ADDENDUM

Project: Grand Lake St. Mary's State Park, Park Office Renovation
Project No.: DNR-250013
Date: October 21, 2025
Addendum No.: 1

B500.1 ADA CLEARANCE
A500.1 SCALE: N.T.S.

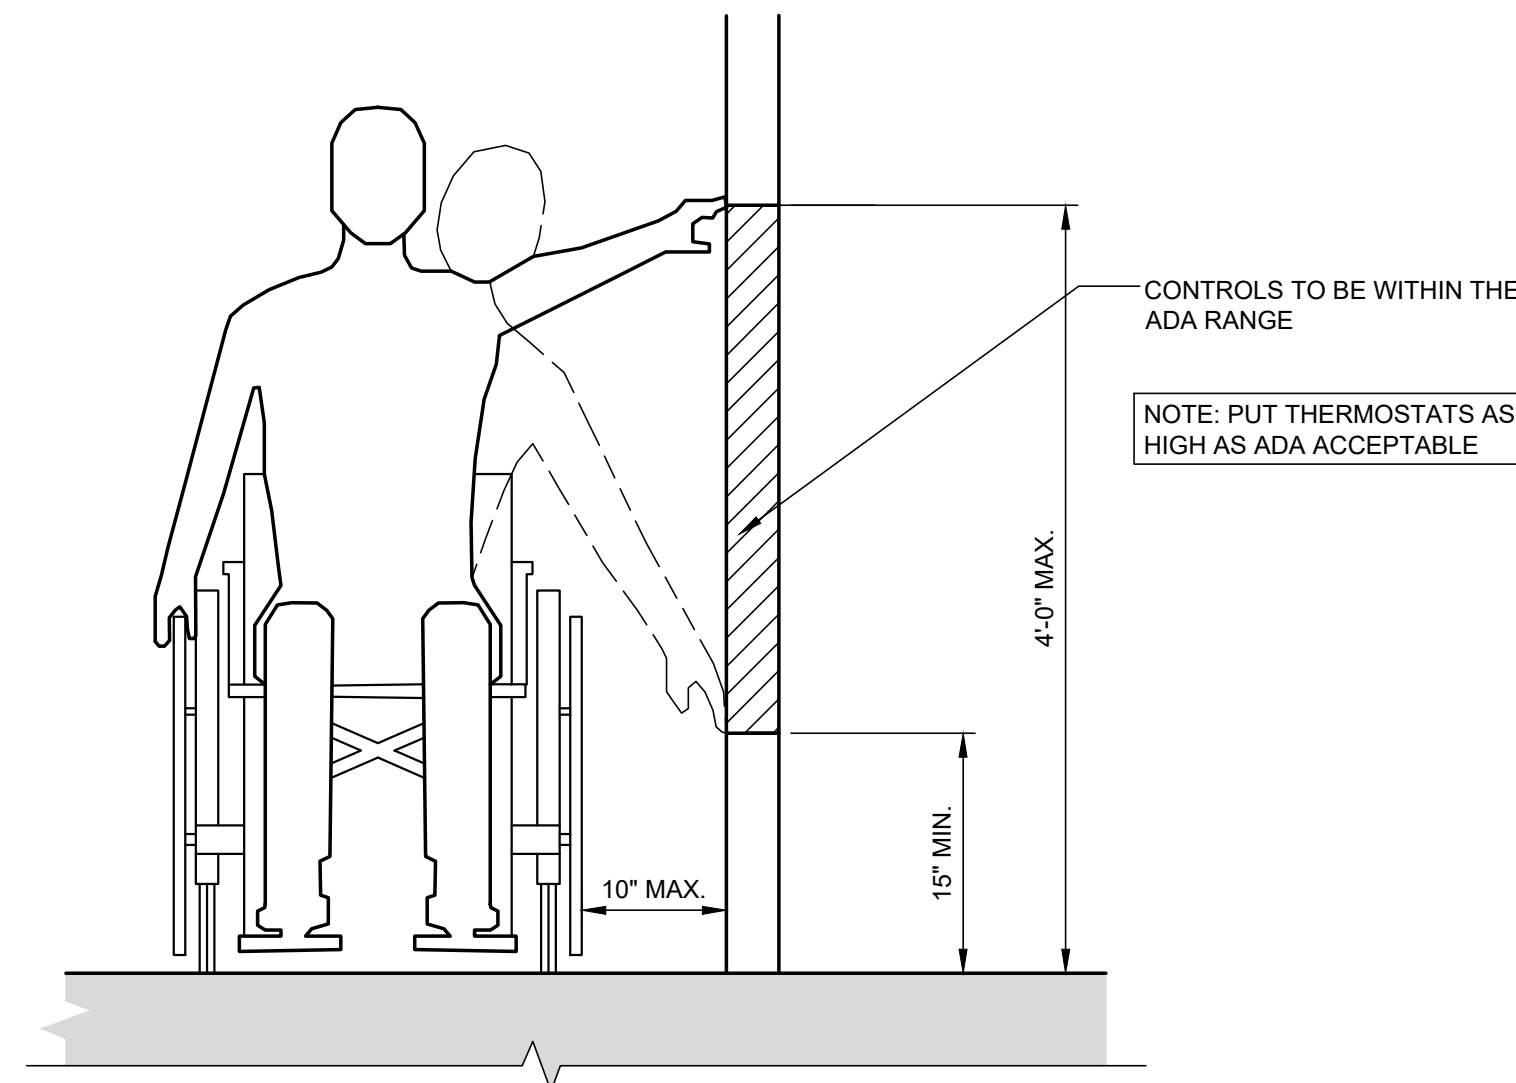
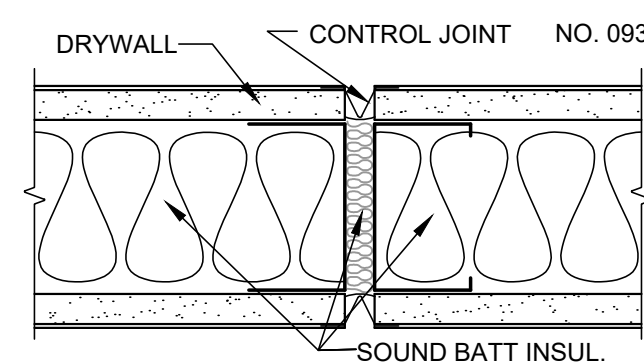
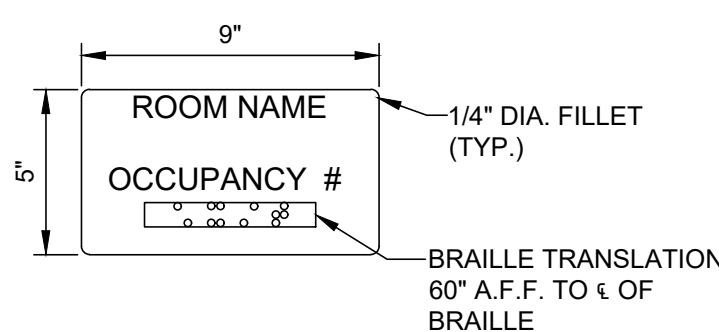
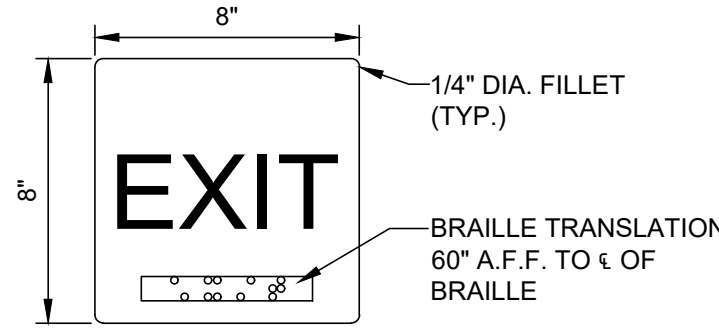
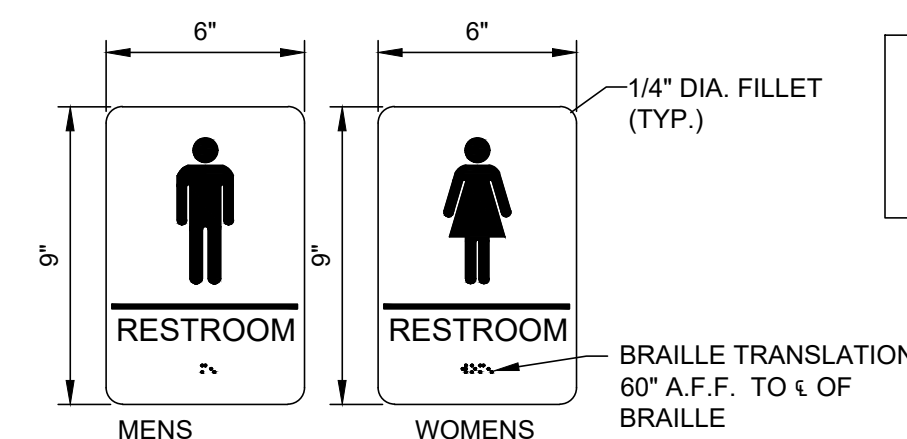
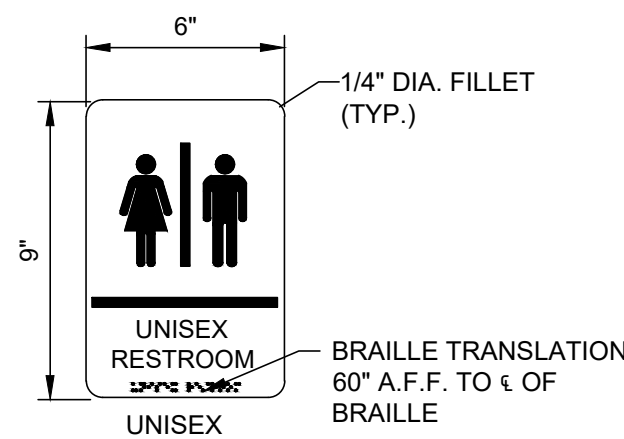
Item 8 – A500.1 (Revised)

- Before final floor finish is installed in drained areas of restrooms, floors shall be water tested / flooded to insure no puddling and positive drainage occurs before final finish coat is applied.

OFFICE 116
K200.1
A900.4
SCALE: 1/4"=1'-0"

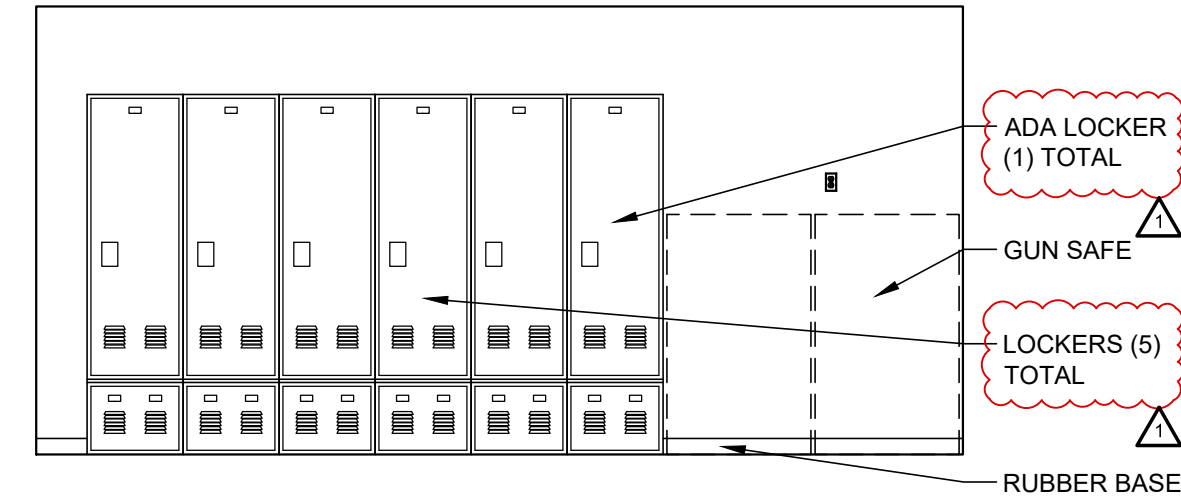
Item 9 – A900.4 (Revised)

- One of the lockers in the office 116 interior elevation K200.1/A900.4 was changed to an ADA locker.

ESP2

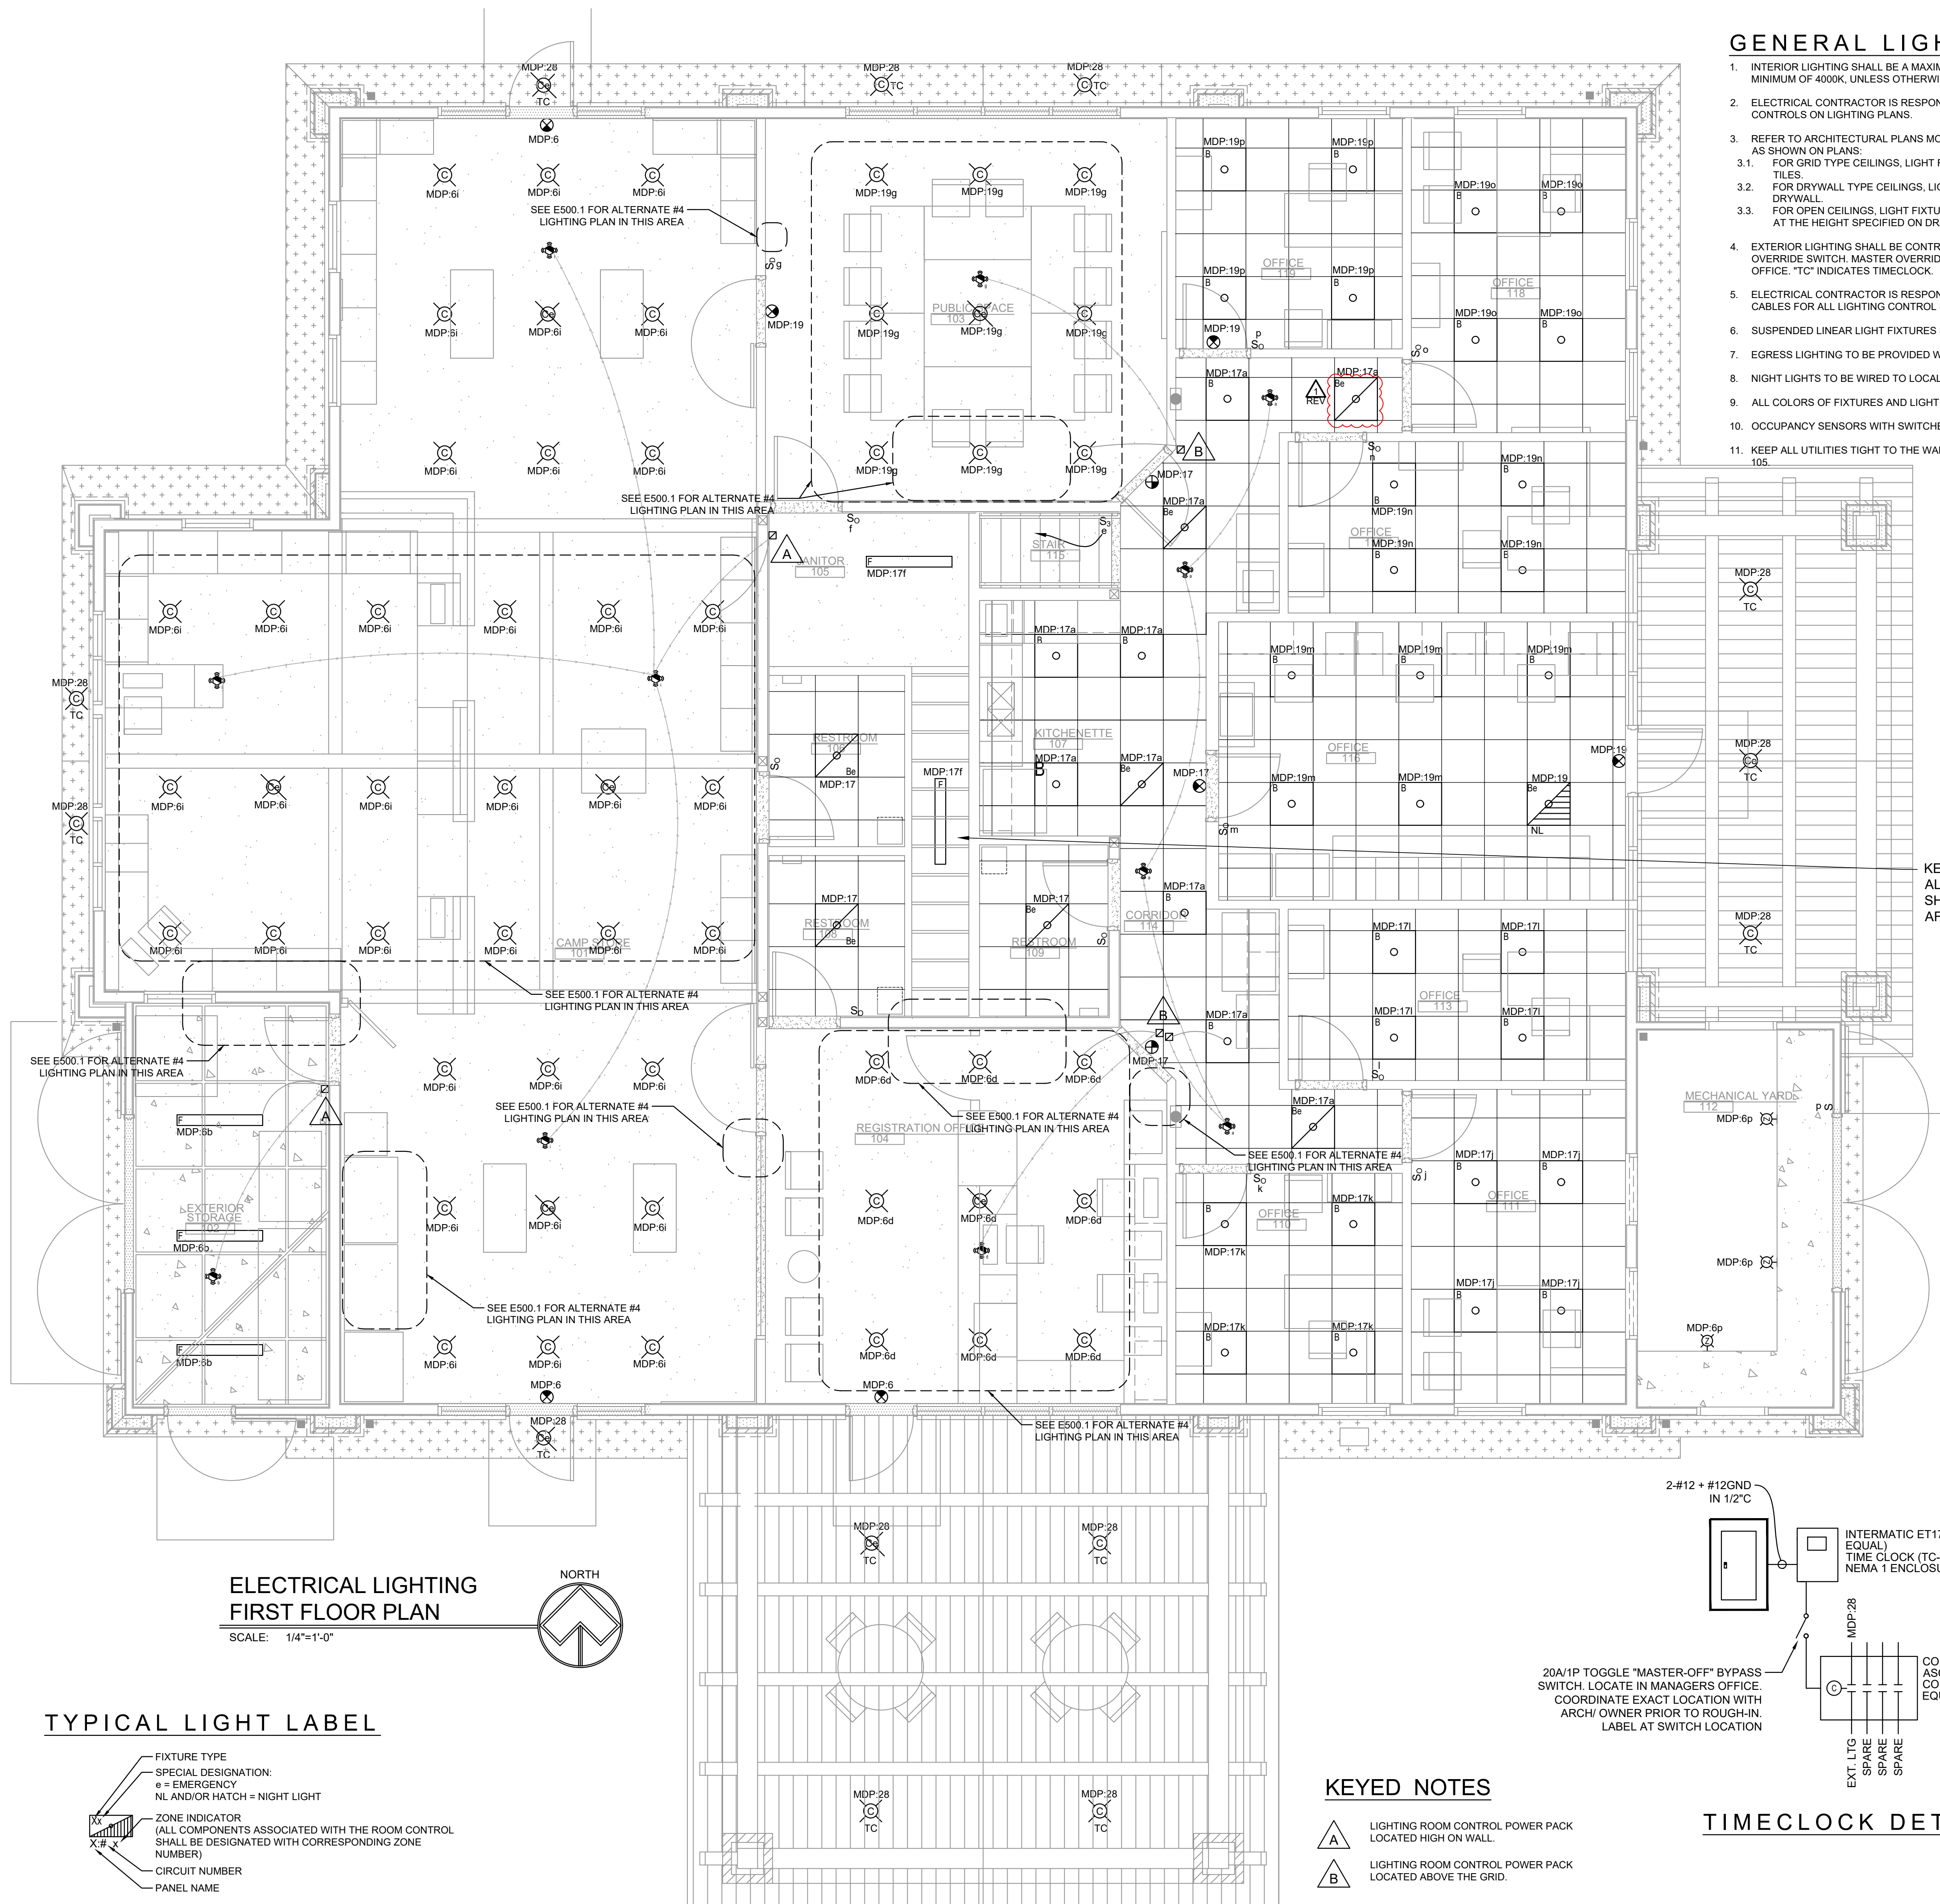
Item 10 – ESP1 & ESP2 (Revised)

- Adjust “campfire connect”, Wi-Fi equipment to align with architecture location within cupola.

E200.1

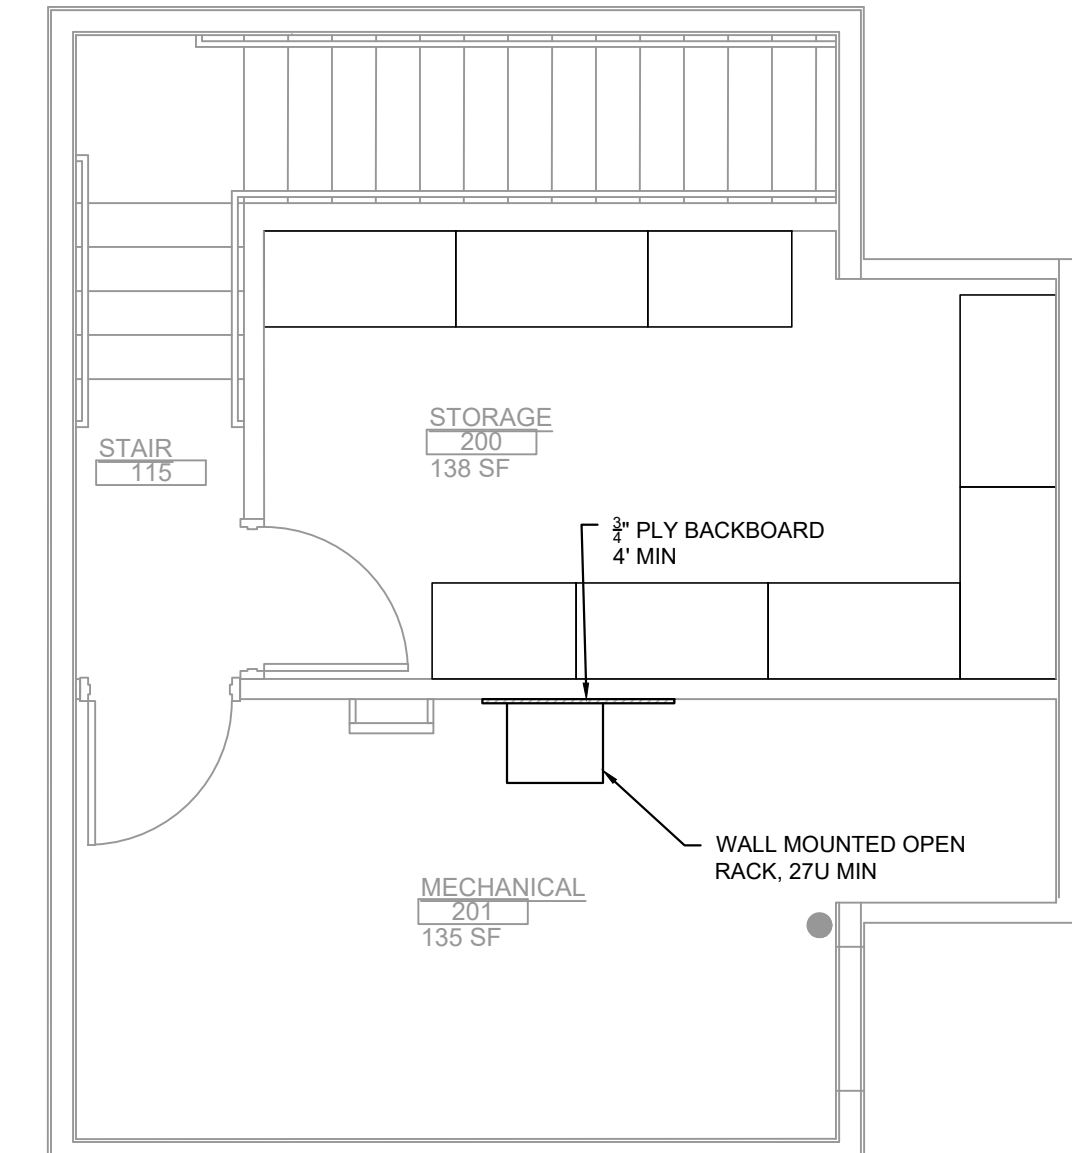
Item 12 – E200.1 (Revised)

- Eliminate the generator connection to match the existing connection. Instead provide a new 50A generator inlet connection and a new generator connection cord.
- Battery option has been added to light fixture “F”. See revised sheet E100.1.
- Circuit A-2 serves a dedicated microwave outlet inside a kitchen cupboard. Outlet has been revised to GFI. Circuit A-12, MDP-13, and various other circuits have GFI protection at the breaker. This is indicated in the panel schedule with a “G” next to the amperage rating of the breaker. The outlet next to the electrical panels has been revised to a GFI outlet. See revised sheet E200.1

E300.1

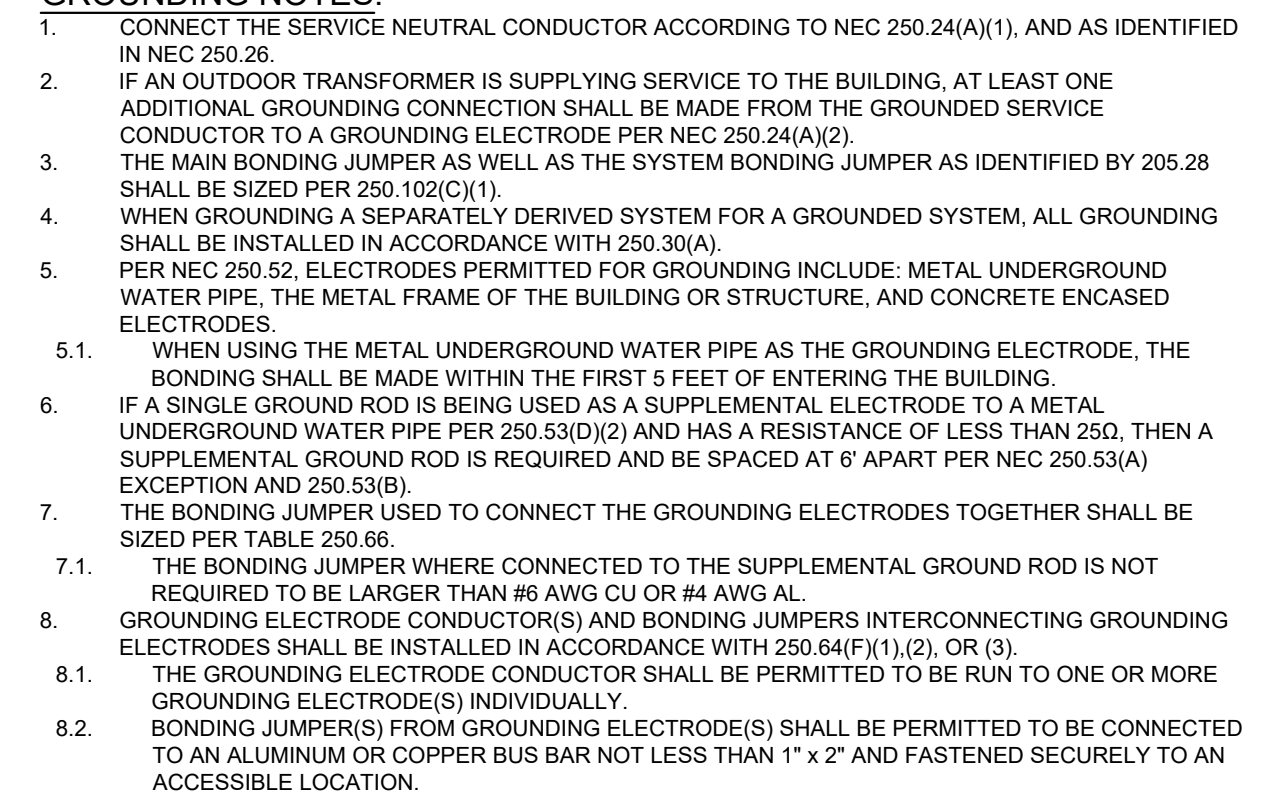
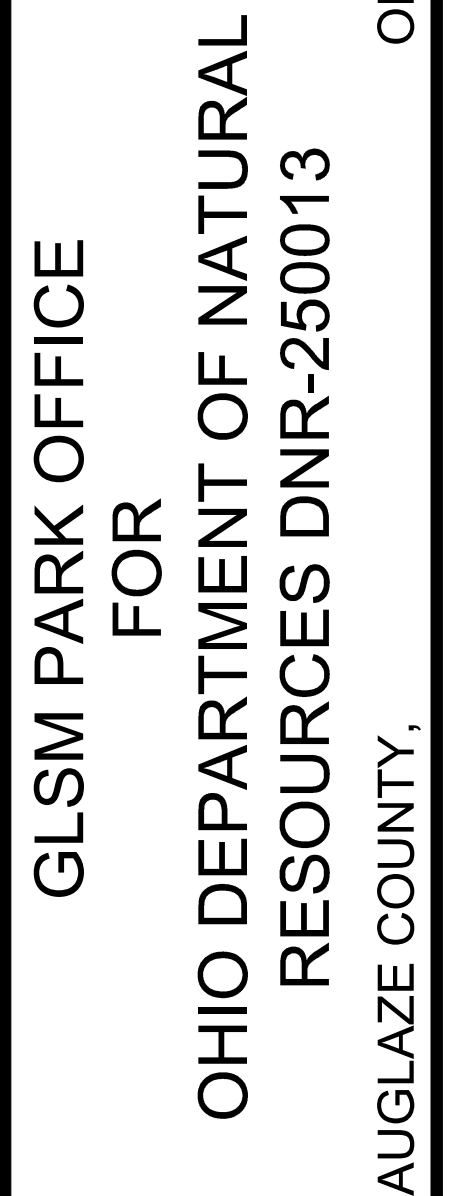
Item 13 – E300.1 & E300.2 (Revised)

- Modify data locations per CD submission comments
